Lowell City Council
Regular Meeting Agenda
Tuesday February 16, 2021, at 7 P.M.
Maggie Osgood Library
70 N. Pioneer Street

1. Motion to approve Land Use Application #2019-04 in the matter of the Sunset Hills Subdivision owned by Bahen Investments, LLC and located on Assessor's Map and Tax Lot #19-01-14-21-05000.
 - a. Staff report from Henry O. Hearley, Associate Planner with Lane Council of Governments
 - b. Public hearing
 - c. City Council discussion
 - d. Motion to approve Land Use Application #2019-04

Agenda Item Sheet
City of Lowell City Council

GRADING & DRAINAGE 2

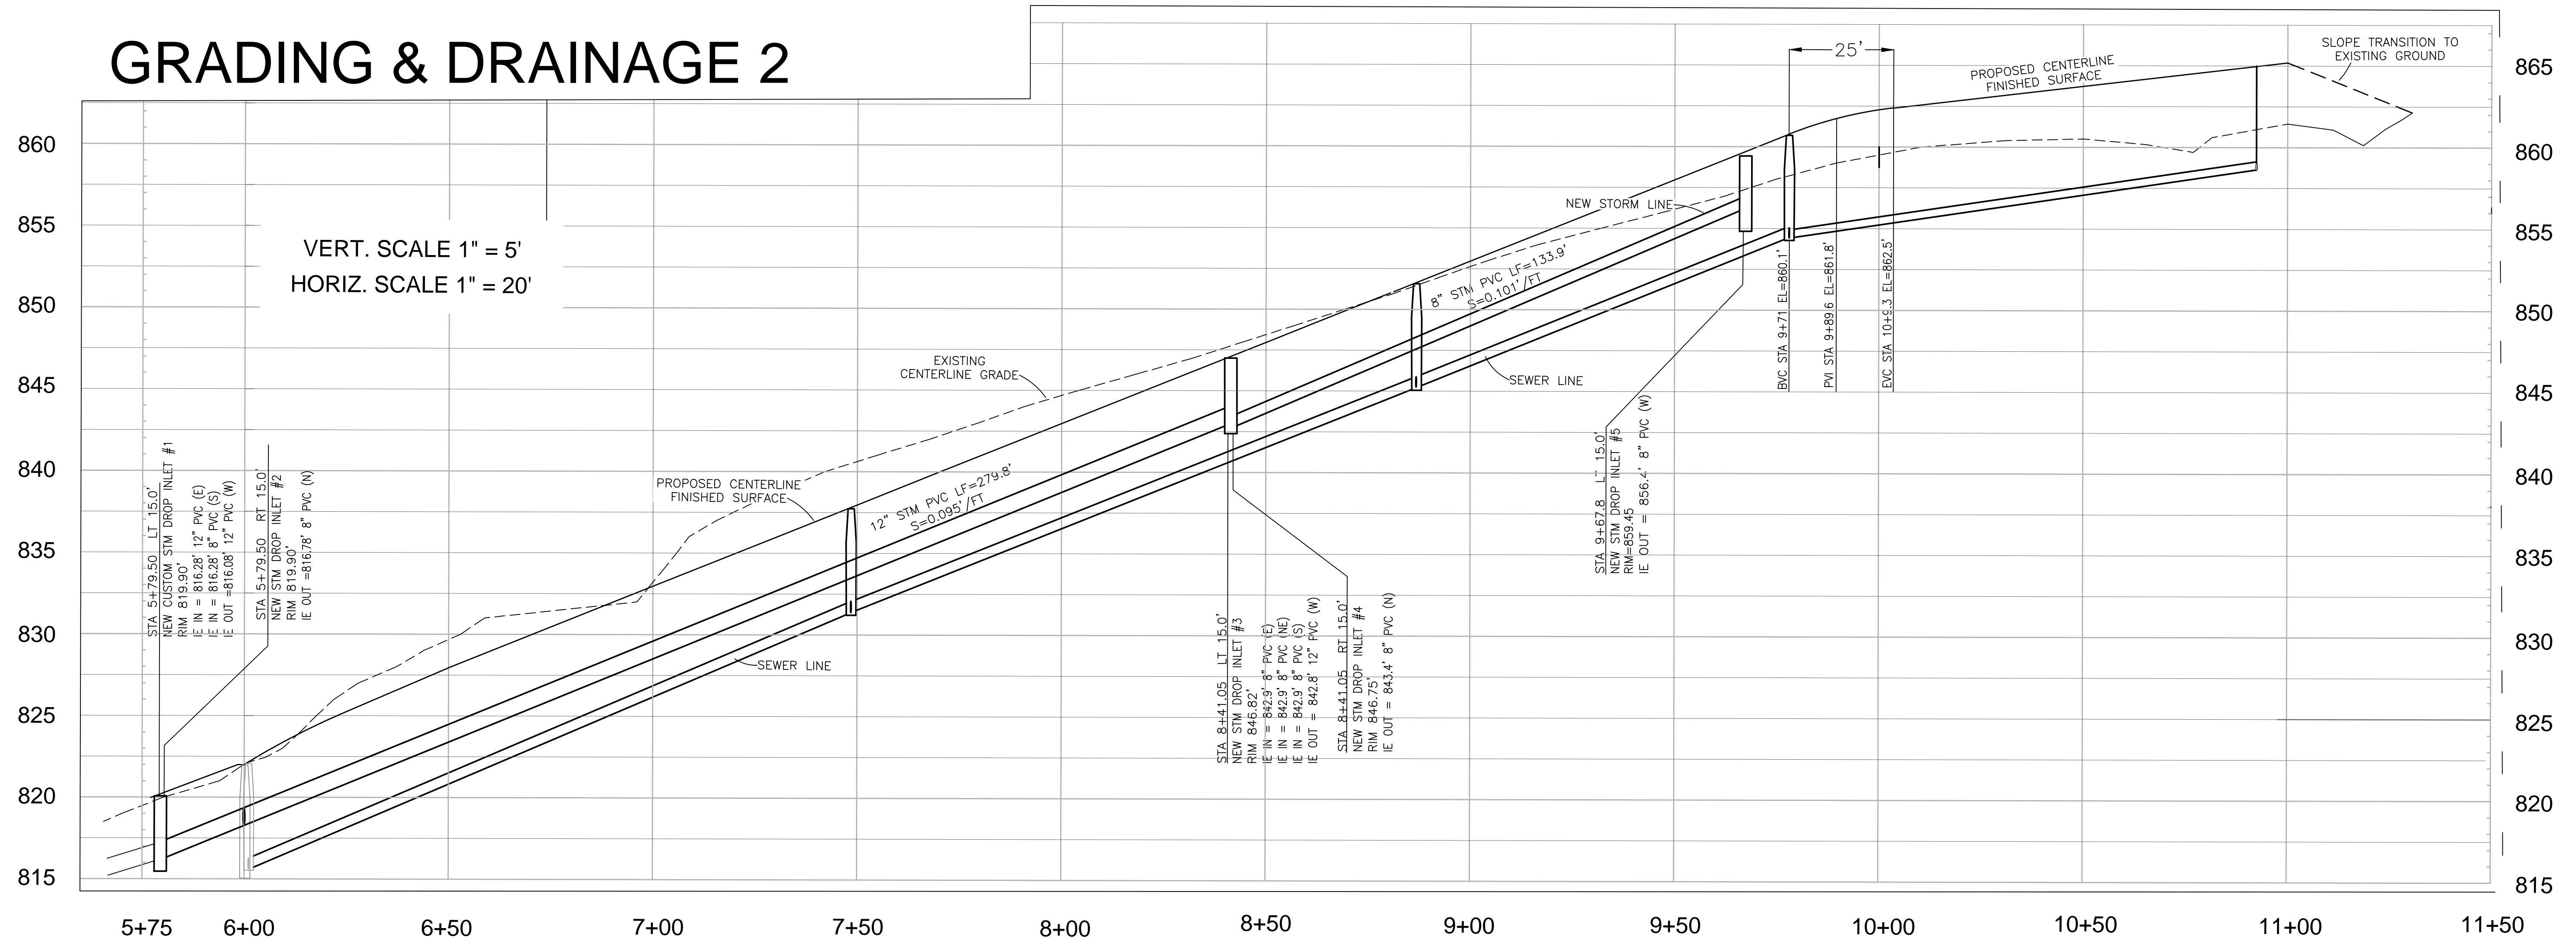
The staff report says “Prior to the issuance of building permits, the applicant shall submit specific construction plans to the City Administrator, or his or her designee, for review and approval.” But Sheet 3’s proposed grading plan IS a specific construction plan, with detailed finished grades down to the foot, and it clearly violates the city’s standards. We don’t know what a compliant plan would look like. It may require a redesign of key aspects of the development.

b) The sewer main is located under a steep fill bank and will be inaccessible for maintenance. As can be seen on Sheet 3 of the original plans (which have not been updated), this sewer line is proposed to be located under a 1:1 fill bank, with a drainage swale on top of that. This city will not be able to access and maintain this line, unless the sewer line is moved to the east, well away from the fill bank and drainage swale. The proposal violates SPI(III)(B)(4).
